Deviation From Design

DfD : **DfD-0015**

**Taran Laval – SAAA Builder 7417
Van's Aircraft RV7 - 73918**

ELEVATOR RHS AFT UPPER HOLE RIVET CHANGE

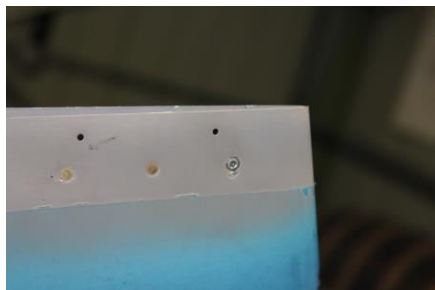
AFT MOST UPPER TIP RIB HOLE INACCESSABLE FOR RIVETING

INSTALLED MK-319-BS BLIND RIVET IN ONE LOCATION
